## **Arkema Project Area PDI Work Plan Comment Resolution Approach**

### **Summary and Tentative Agreements from the LSS/EPA Meeting on September 30, 2020**

**Figure 3-1. (Proposed Revisions)**  
Summary of Proposed Remedial Design Investigation Subsurface Sediment and Riverbank Soil Chemistry Sampling Stations  
Arkema Project Area Pre-design Investigation Work Plan

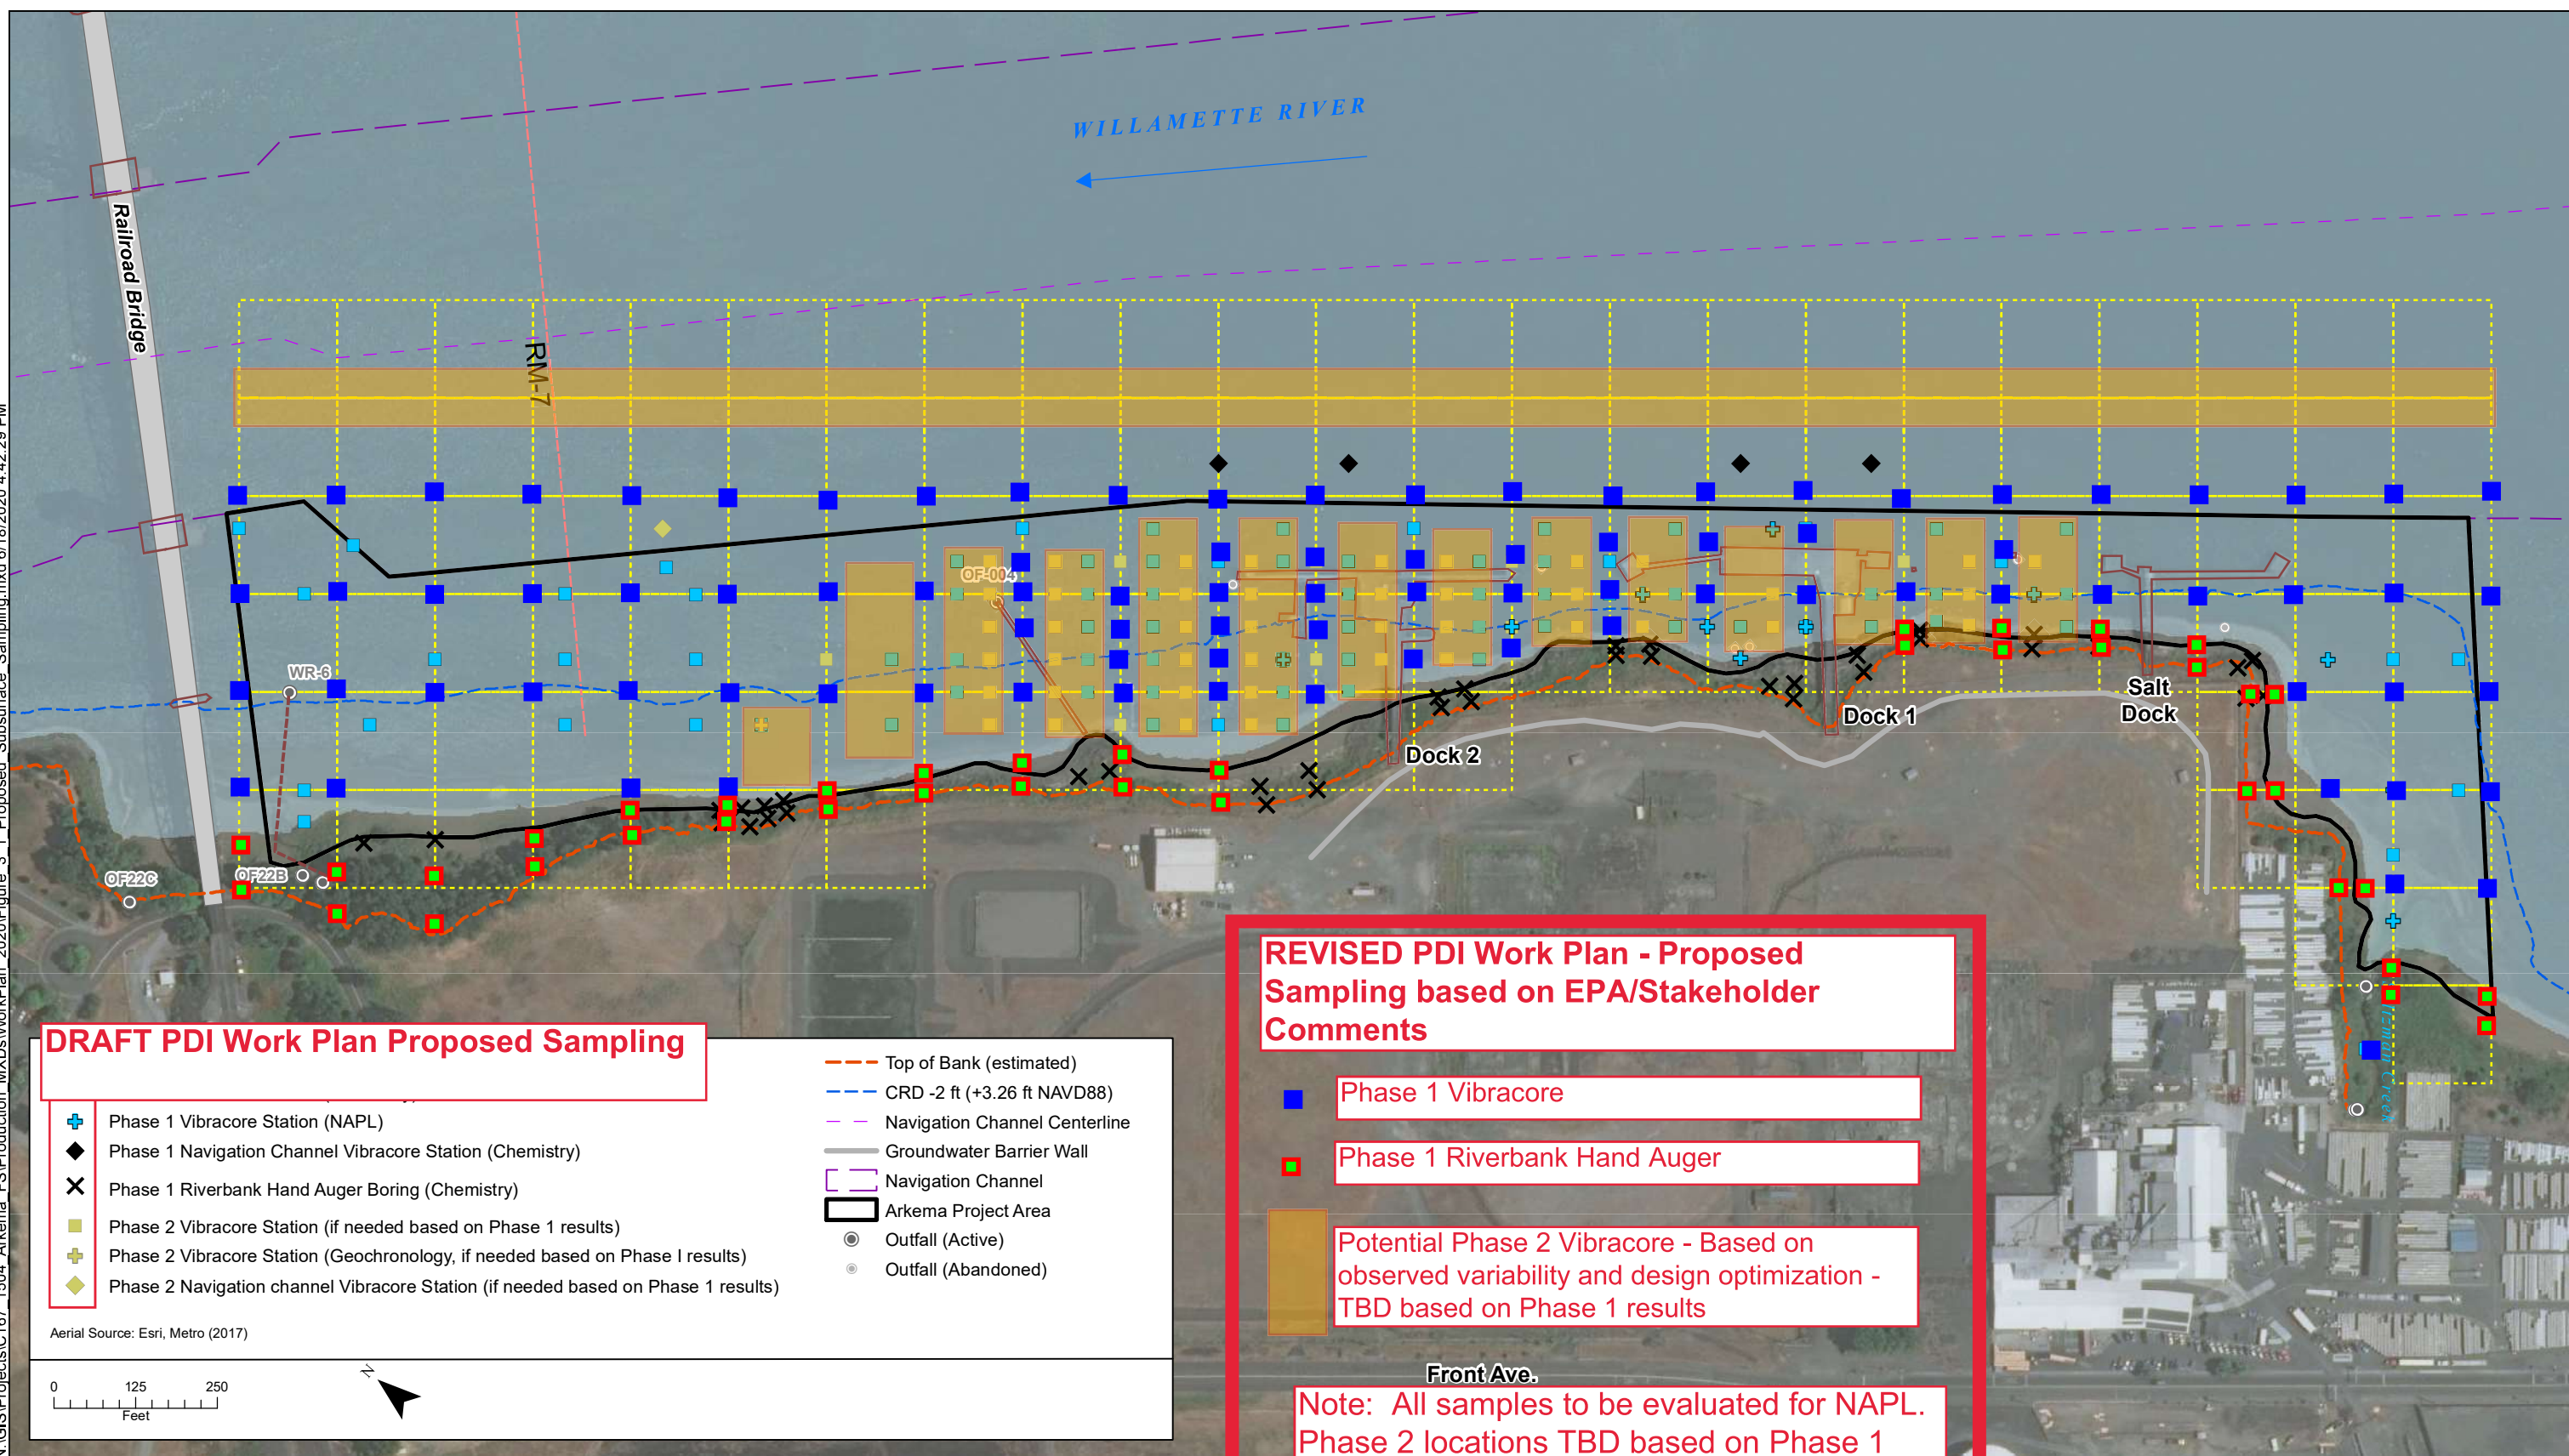
An alternate sampling scheme has been developed based on a 150-ft grid to address the EPA team comments. The conceptual map in Attachment 1 shows the revised proposed sediment core stations for Phase I. The boundary of the Arkema Project Area is defined based on 150-ft sampling and step outs as needed based on the Phase I sampling results. Sediment cores have been added along the navigation channel to create a maximum 150-ft spacing with step out criteria. In areas where dredging is the presumptive remedy (e.g., between Docks 1 and 2), reduced sediment sampling will be conducted as needed for defining the limits in the interior of the dredge area.

Surface sediment sampling is not proposed for the Phase I investigation. The need for surface sediment sampling will be assessed later in the design process and will only be recommended for areas where dredging is not anticipated. Surface sediment sampling is not necessary for areas that are targeted for dredging because the sediment will be removed.
